Braidwood Station, Units 1 and 2
Facility Operating License Nos. NPF-72 and NPF-77
NRC Docket Nos. STN 50-456 and STN 50-457

Byron Station, Units 1 and 2
Facility Operating License Nos. NPF-37 and NPF-66
NRC Docket Nos. STN 50-454 and STN 50-455

Subject: Response to NRC Request for Additional Information With Respect to Request for License Amendment Related to Application of Alternative Radiological Source Term

Response to NRC Request for Additional Information

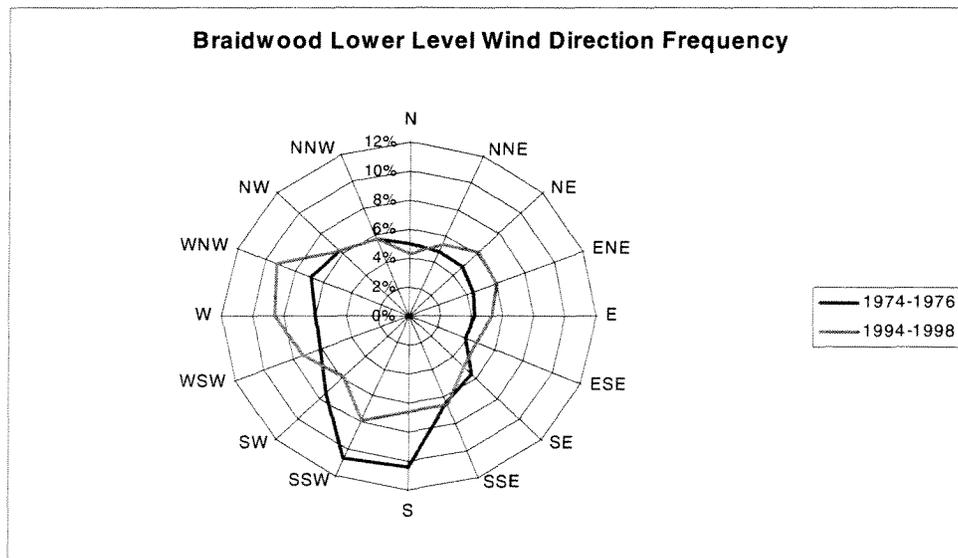
2. A wind rose comparing the Braidwood lower level wind direction frequency distributions between the 1974 - 1976 data presented in Braidwood Updated Final Safety Analysis Report (UFSAR) Table 2.3-4 and the 1994 - 1998 data presented in Attachment 8 to your application letter dated February 15, 2005, is provided below:

This wind rose shows considerable discrepancies for the following wind direction sectors:

Period of Record	Wind Direction Sector			
	S	SSW	W	WNW
1974 - 1976	10.3%	10.7%	5.9%	6.8%
1994 - 1998	6.6%	7.7%	8.5%	9.1%

Please explain what might have caused these discrepancies in reported wind direction frequency distributions between the 1974 - 1976 and 1994 - 1998 data sets (e.g., changes in tower structure and/or boom orientation, vegetation growth, etc.) and the potential impact on the resulting atmospheric dispersion analyses.

Murray and Trettel, Inc. (the Exelon Generation Company, LLC (EGC) meteorological contractor) first began maintaining the meteorological equipment in 1975 and began providing reports based on data collected from May 1975 to present.

The period of record from 1974 through 1976 utilizes only three full years of data. The period of 1994 through 1998 utilizes five full years of data. The smaller data set associated with the 1974 through 1976 data may have had some impact on the wind direction sector frequencies. The wind direction sector frequencies for 1994 through 1998 are more consistent with what would be anticipated based upon known geographic location and topography.

The 1974 through 1976 data set was obtained prior to plant startup in 1987 and 1988. At that time, the man-made cooling lake had not been completely constructed and did not have any water inventory that could have affected local meteorology. Although this may only have affected the wind speed due to less ground friction, it is uncertain if it could also have affected the wind direction.

There were no changes in tower structure, boom orientation, or obvious instrumentation issues that could account for the lower level wind direction shift over the previous 20 years. There is no significant vegetation in the immediate vicinity of the meteorological monitoring tower. Routine calibrations and maintenance were performed on the required meteorological monitoring tower instruments. Murray and Trettel, Inc. noted that the lower level wind sensors were replaced in November 1993.

An additional review of the Braidwood Station meteorological tower (lower level) year-by-year wind direction percentage occurrence frequencies for 1994-1998 shows that there is a relatively higher degree of variability with respect to wind directions SSW, W and WNW than the other directions as shown in the Table below. These happen to be three of the four directions associated with the percentage occurrence "discrepancies" identified by the NRC. The Table shows that the maximum wind direction occurrence is either SSW or WNW in each of the five years. The Table also indicates that annual occurrence frequency varies more for these two directions than the others. West, the second most frequent wind occurrence direction, is third highest in annual variation.

While there may be other factors contributing to the differences identified by the NRC in the 1974-1976 and 1994-1998 Braidwood Station meteorological tower databases (e.g., topographical changes to the site environs), the natural climatological variability cannot be excluded as a significant contributor.

The 1994-1998 Braidwood Station lower level wind direction data set is considered more representative of current conditions than the 1974-1976 data set.
